DOMINION NUCLEAR CONNECTICUT, INC.
MILLSTONE POWER STATION UNIT 3
ASME SECTION XI INSERVICE INSPECTION PROGRAM
RELIEF REQUESTS FOR LIMITED COVERAGE EXAMINATIONS PERFORMED IN
THE THIRD 10-YEAR INSPECTION INTERVAL

RELIEF REQUEST IR-3-19
EXAMINATION CATEGORY B-A
PRESSURE RETAINING WELDS IN REACTOR VESSEL

RELIEF REQUEST IR-3-20
EXAMINATION CATEGORY B-D
FULL PENETRATION WELDED NOZZLES IN VESSELS –
INSPECTION PROGRAM B

RELIEF REQUEST IR-3-21
EXAMINATION CATEGORY C-A
PRESSURE RETAINING WELDS IN PRESSURE VESSELS

Component ID: 101-101

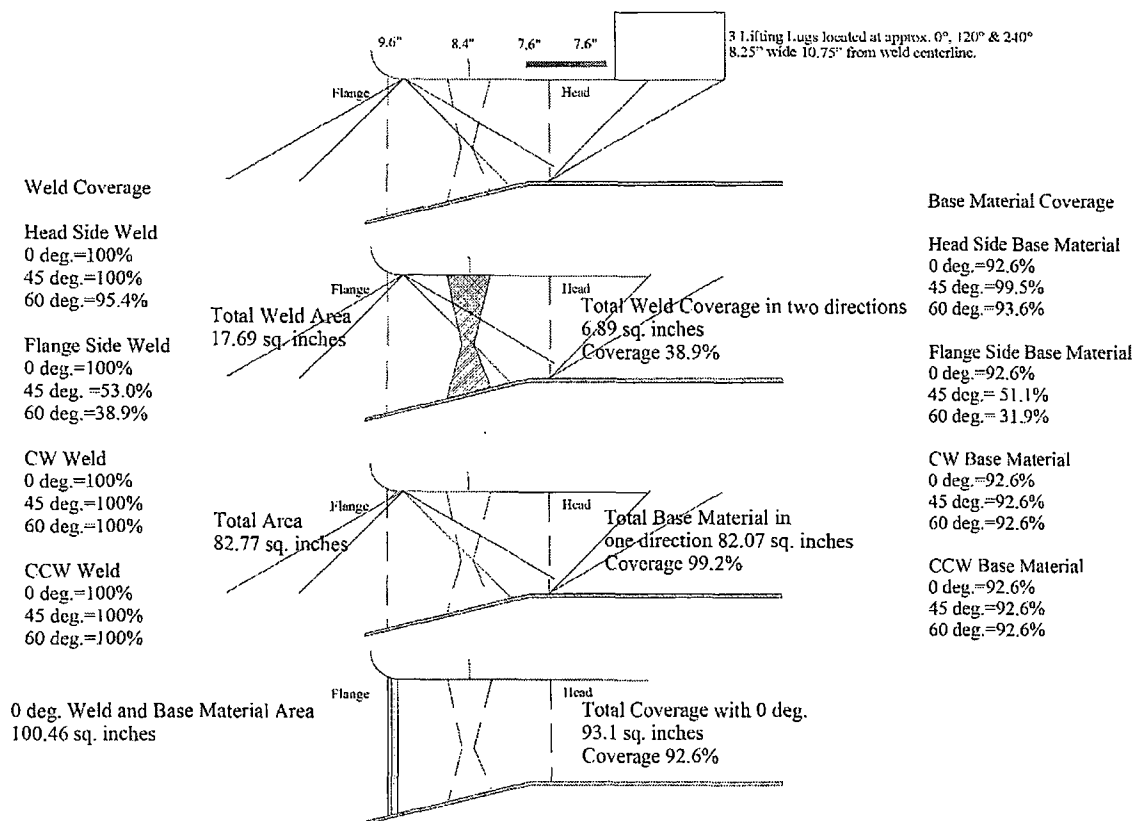
Weld Volume = $[38.9\% \text{ (Perpendicular scan)} + 100\% \text{ (Parallel scan)}] / 2 = 69.4\%$
Base Material Volume = $[93.6\% \text{ (Perpendicular scan)} + 92.6\% \text{ (Parallel scan)}] / 2 = 93.1\%$
Total Coverage = 81.2%

Weld ID: 03-003-SW-U

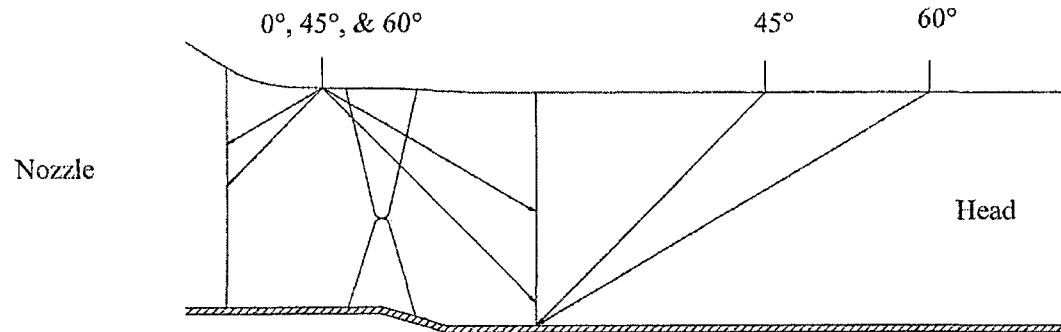
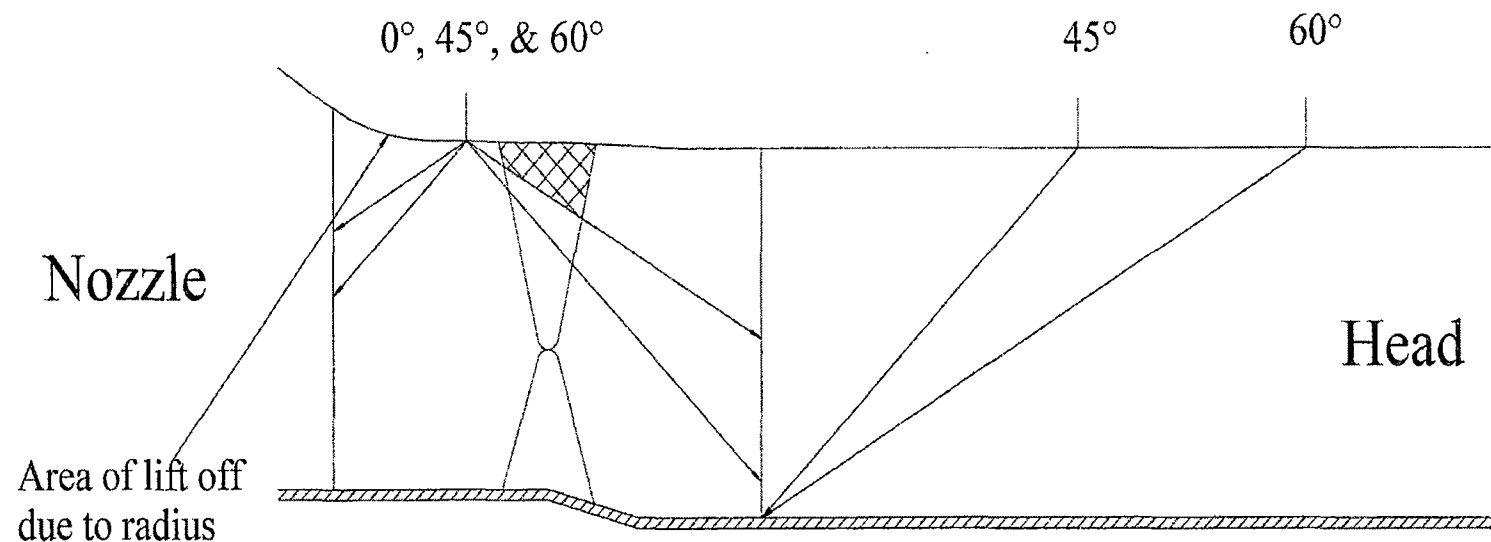
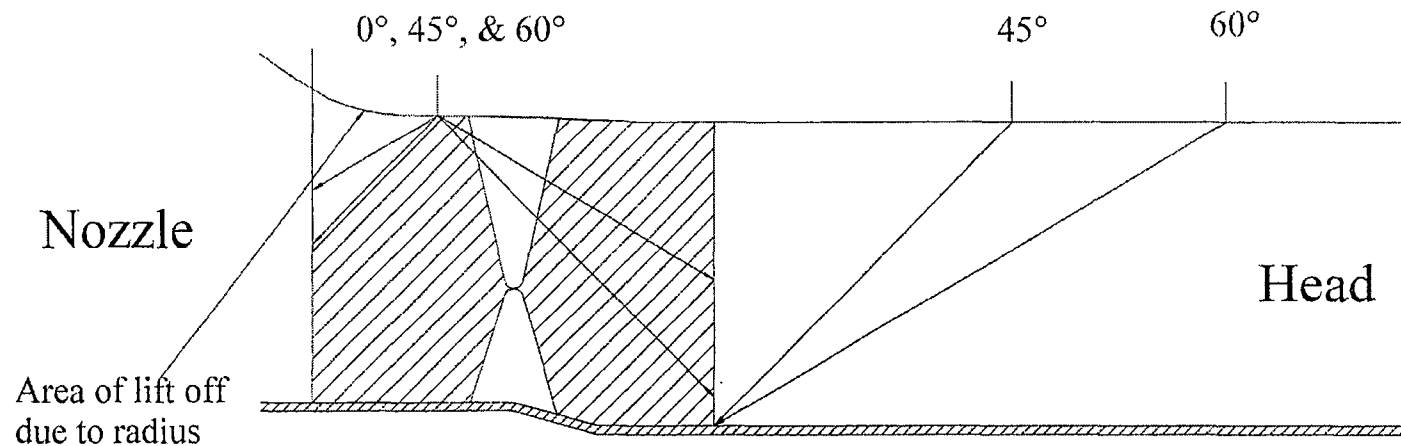
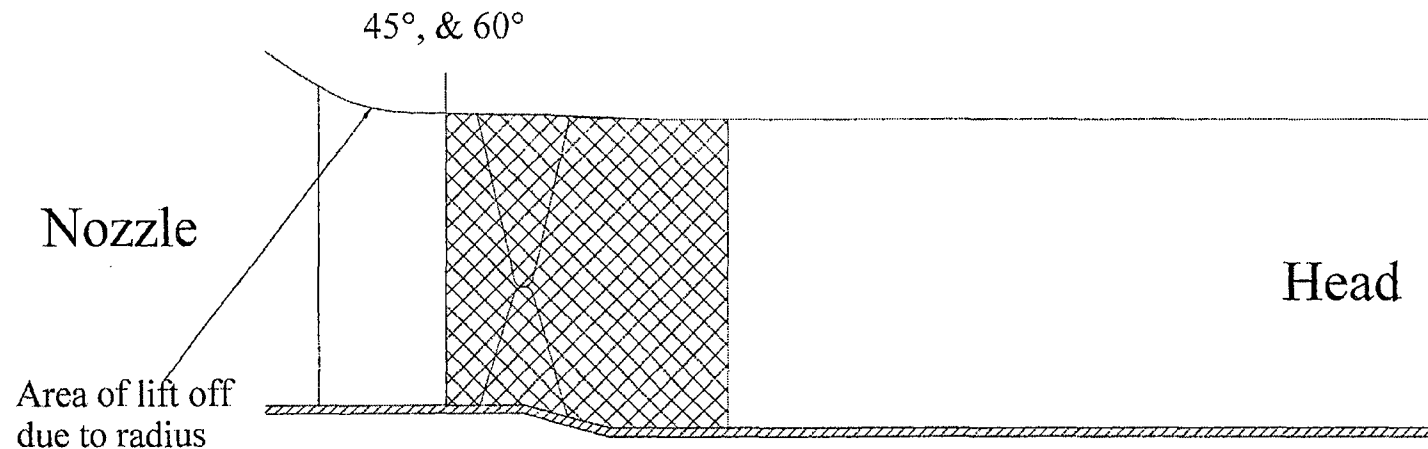
Weld Volume = [22.9% (Perpendicular scan) + 100% (Parallel scan)]/2=61.5%

Base Material Volume =[94.5% (Perpendicular scan) + 64.5% (Parallel scan)]/2=79.5%

Total Coverage = 70.5% Coverage

Weld metal examination coverage with the beam direction perpendicular to the weld axis. Complete coverage is limited due to the nozzle radius.

Area effectively examined with two angles in two directions = 0.9037 sq. in. = 22.9%

Weld ID: 03-003-SW-V

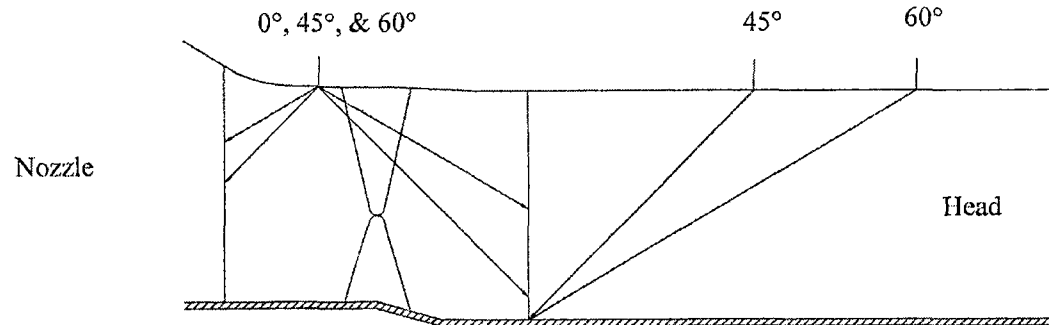
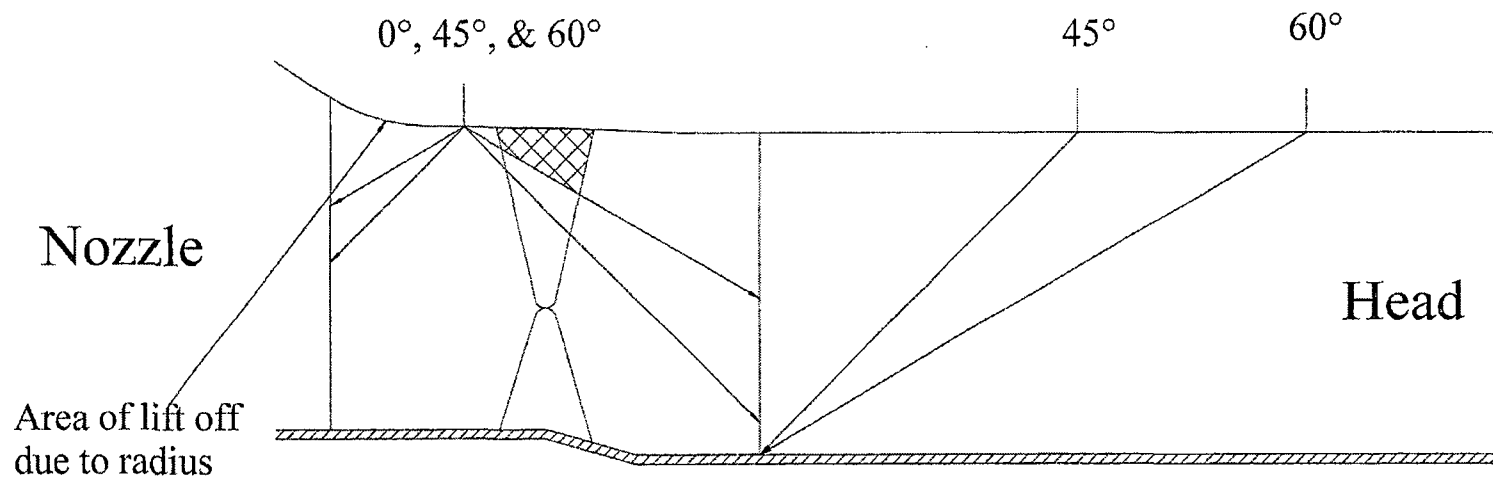
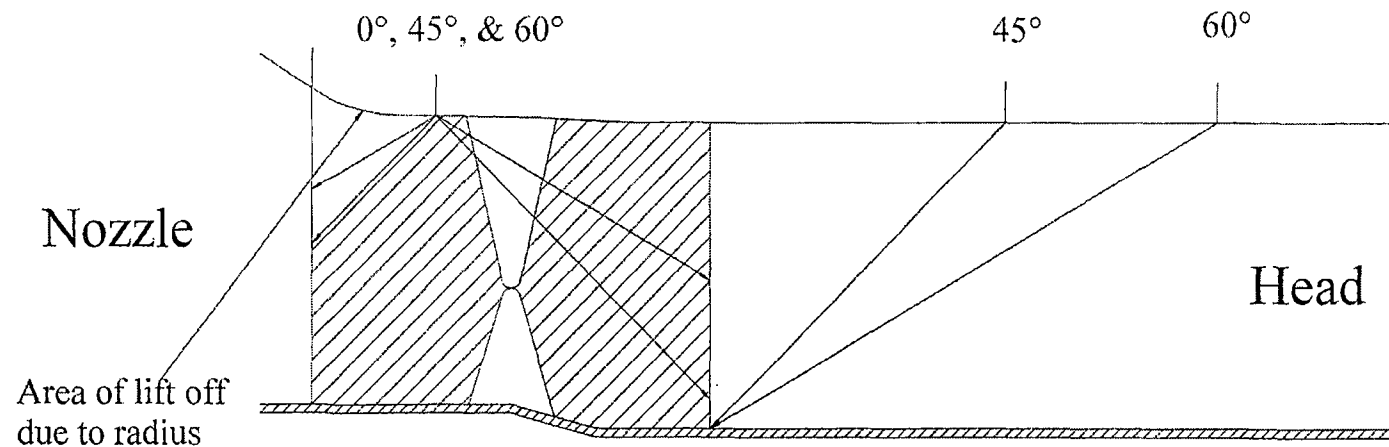
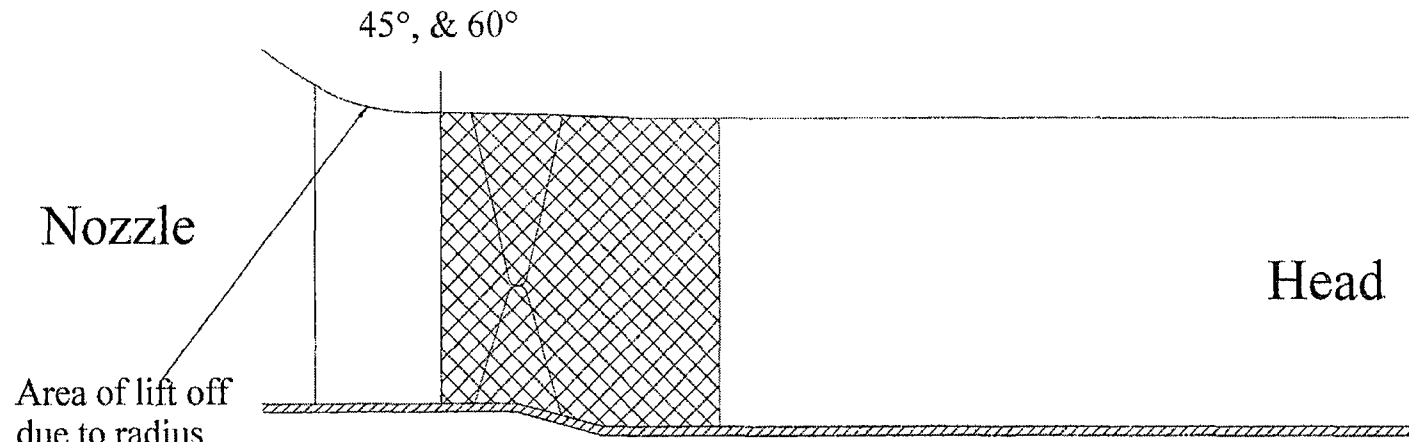
Weld Volume = [22.9% (Perpendicular scan) + 100% (Parallel scan)]/2=61.5%

Base Material Volume = [94.5% (Perpendicular scan) + 64.5% (Parallel scan)]/2=79.5%

Total Coverage = 70.5% Coverage

Weld metal examination coverage with the beam direction perpendicular to the weld axis.
Complete coverage is limited due to the nozzle radius.

Area effectively examined with two angles in two directions = 0.9037 sq. in. = 22.9%

Weld ID: 03-004-SW-U

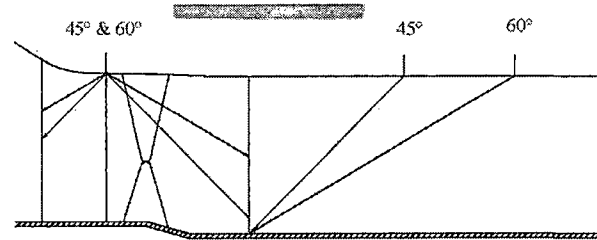
Weld Volume =[22.9% (Perpendicular scan)+100% (Parallel scan)]/2=61.5%
 Base Material Volume=[91.5%(Perpendicular scan)+69.3%(Parallel scan)]/2=80.4%
 Total Coverage = 70.9%

Weld ID: 03-004-SW-V

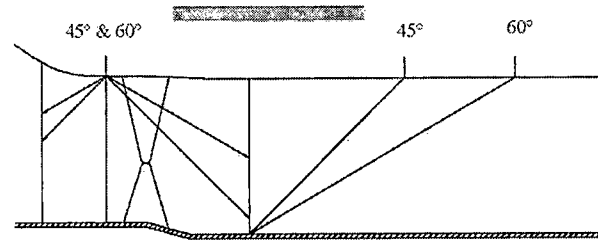
Weld Volume =[22.9% (Perpendicular scan)+100% (Parallel scan)]/2=61.5%
Base Material Volume=[91.5%(Perpendicular scan)+69.3%(Parallel scan)]/2=80.4%
Total Coverage = 70.9%

Weld ID: 03-007-SW-A

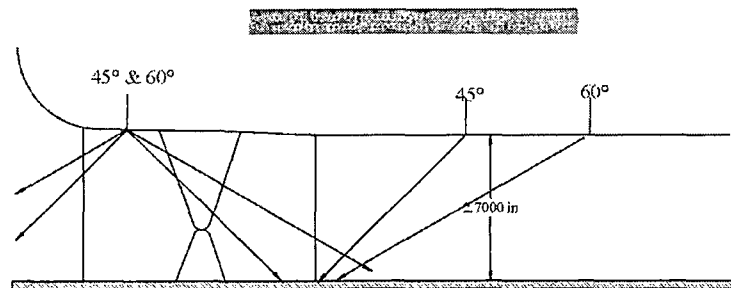
Weld Volume =[43.7% (Perpendicular scan)+100% (Parallel scan)]/2=71.8%

Base Material Volume=[96.7%(Perpendicular scan)+88.0%(Parallel scan)]/2=92.3%

Total Coverage = 82.0%

Weld ID: 03-007-SW-E

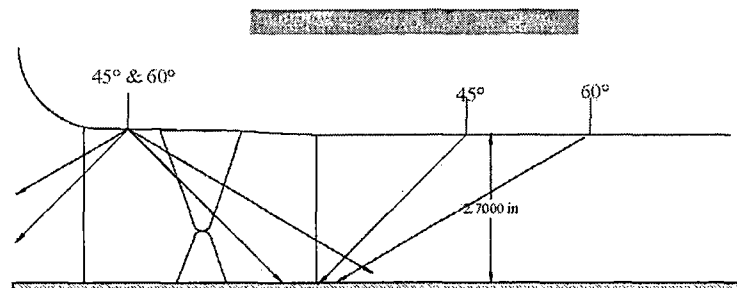
Weld Volume =[43.7% (Perpendicular scan)+100% (Parallel scan)]/2=71.8%
Base Material Volume=[96.7%(Perpendicular scan)+88.0%(Parallel scan)]/2=92.3%
Total Coverage = 82.0%

Weld ID: 03-053-SW-G

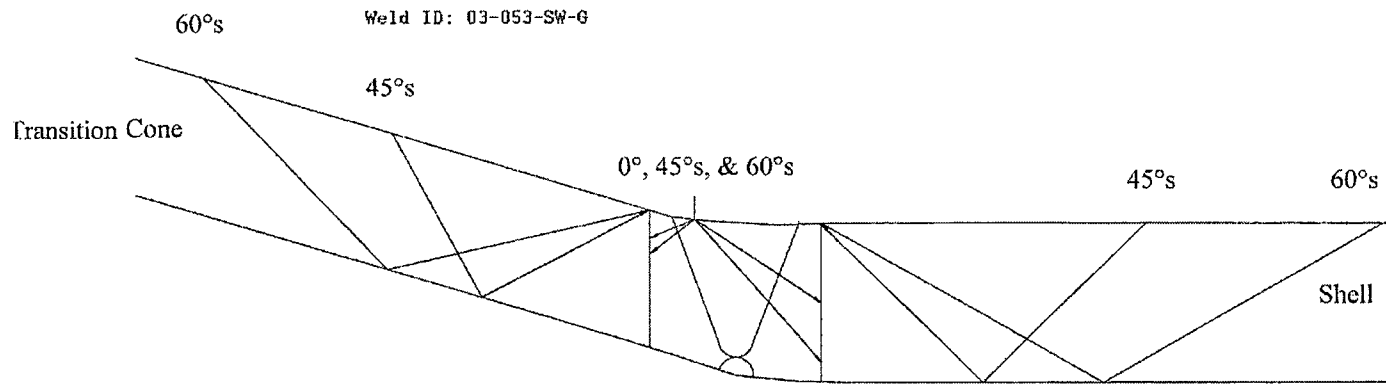
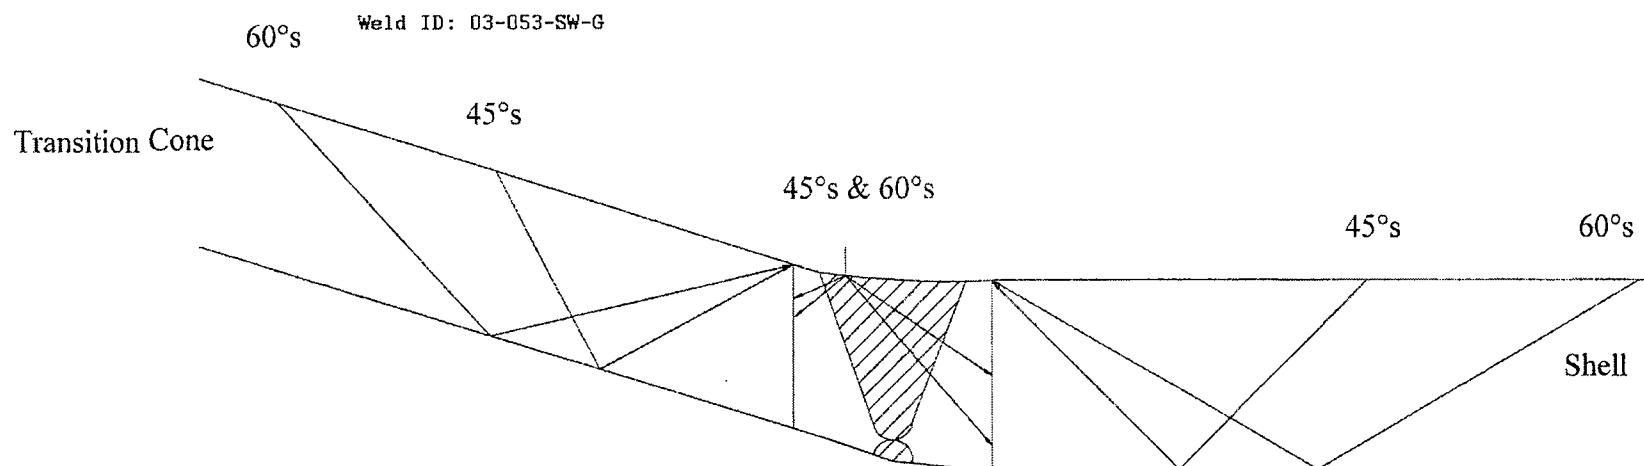
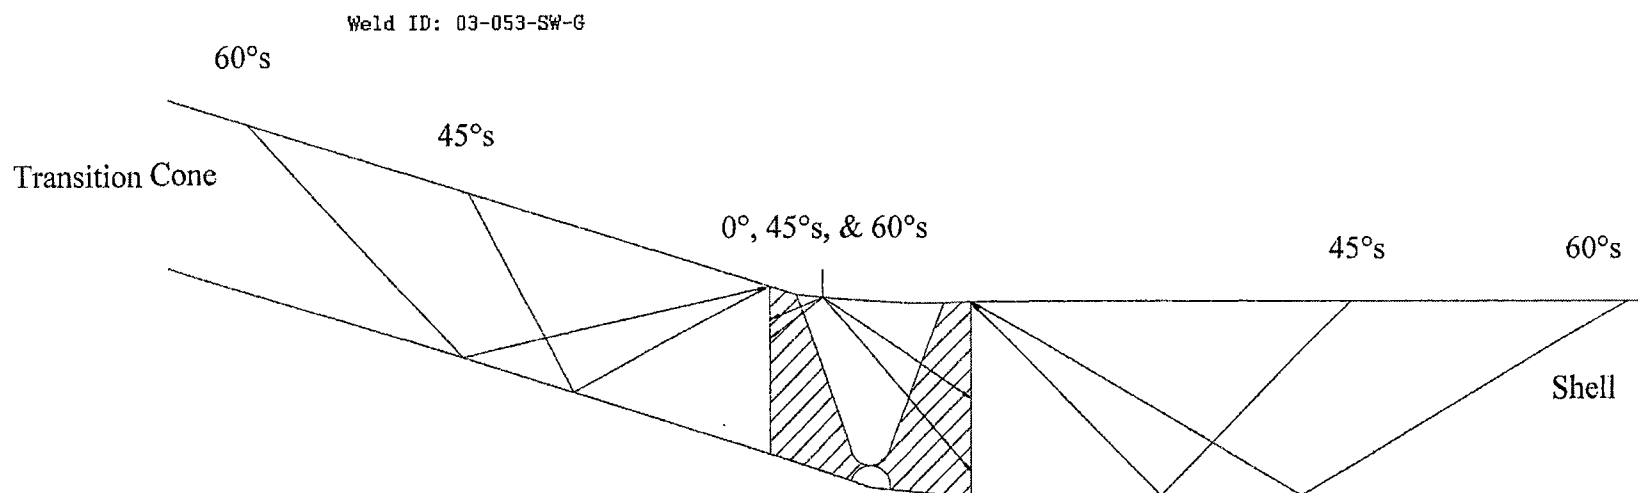
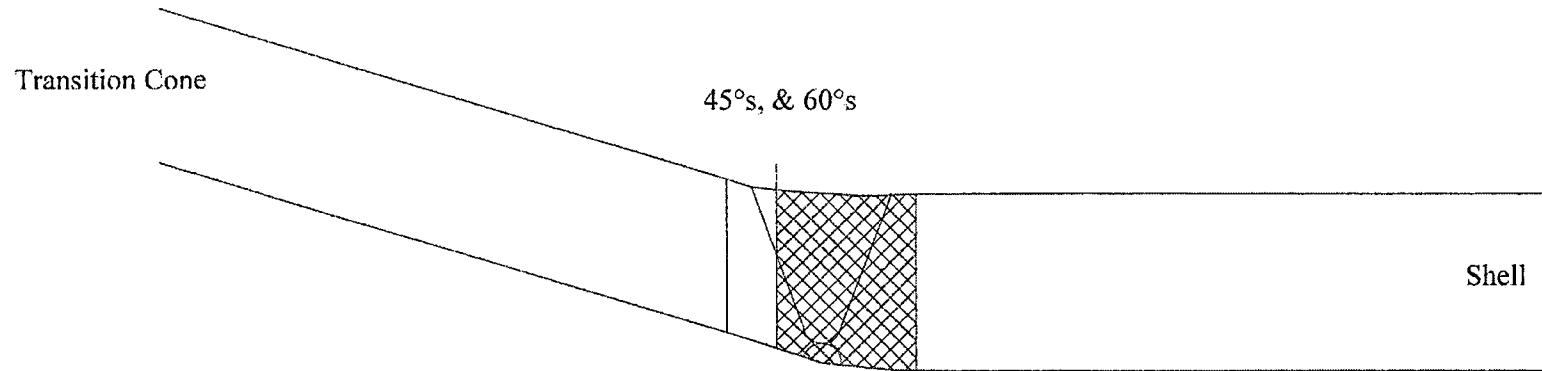
Weld Volume = $[100\% \text{ (Perpendicular scan)} + 93.6\% \text{ (Parallel scan)}] / 2 = 96.8\%$

Base Material Volume = $[100\% \text{ (Perpendicular scan)} + 63.4\% \text{ (Parallel scan)}] / 2 = 81.7\%$

Total Coverage = 89.3% Coverage

Examination coverage with the beam direction parallel to the weld axis.
Complete coverage is limited due to transition from shell to transition cone.
Weld metal and base coverage requires the combination of two angles from two directions.

Total cross section examination area of weld = 5.1071 sq. in.
Weld volume effectively examined with two angles in two directions = 4.7829 sq. in. = 93.6%

Total cross section of base material = 7.6199 sq. in.
Base material effectively examined with two angles in two directions = 4.8355 sq. in. = 63.4%

Weld ID: RHS-9-2-SW-K

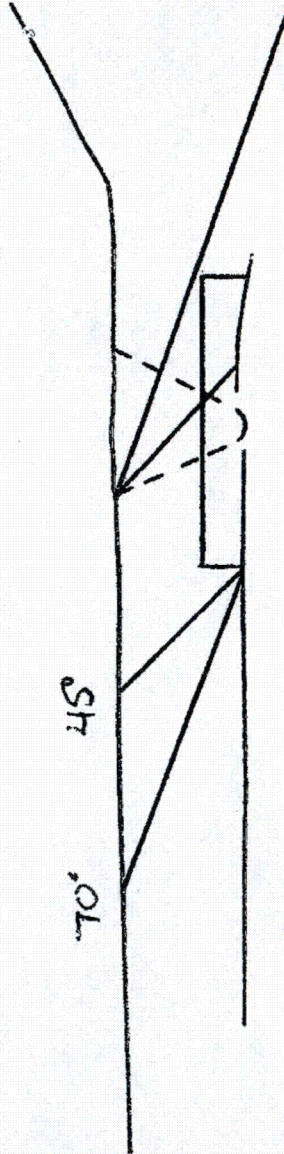
PIPE SIDE AXIAL SCAN	100%
PIPE SIDE CIRC SCAN	100%
FLANGE SIDE CIRC SCAN	0%
FLANGE SIDE AXIAL SCAN	0%

NOTE: An additional 25% total best effort (non-code) coverage was obtained for the flange side axial scan using a 70 degree shear wave search unit.

Weld ID: RHS-9-3-SW-B

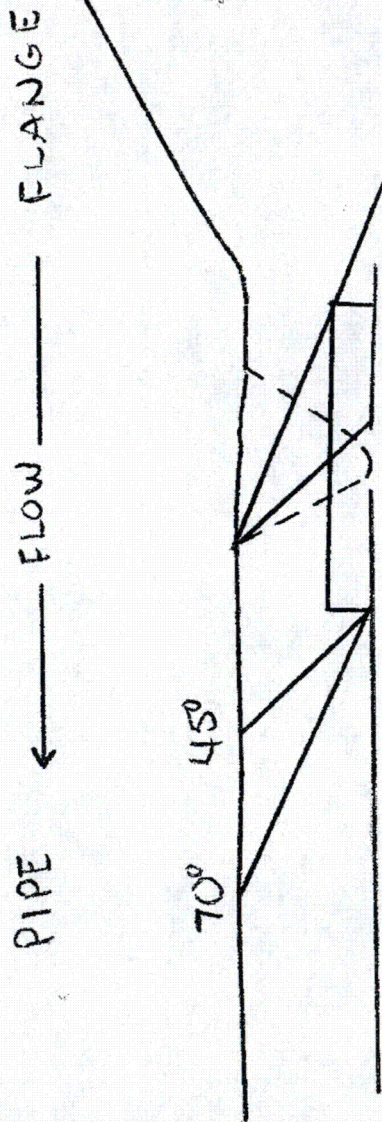
PIPE SIDE AXIAL SCAN	100%
PIPE SIDE CIRC. SCAN	100%
FLANGE SIDE AXIAL SCAN	0%
FLANGE SIDE CIRC. SCAN	0%
TOTAL COVERAGE	$200 \div 4 = 50\%$

NOTE: An additional 25% total best effort (non-code) coverage was obtained for the flange side axial scan using a 70 degree shear wave search unit.
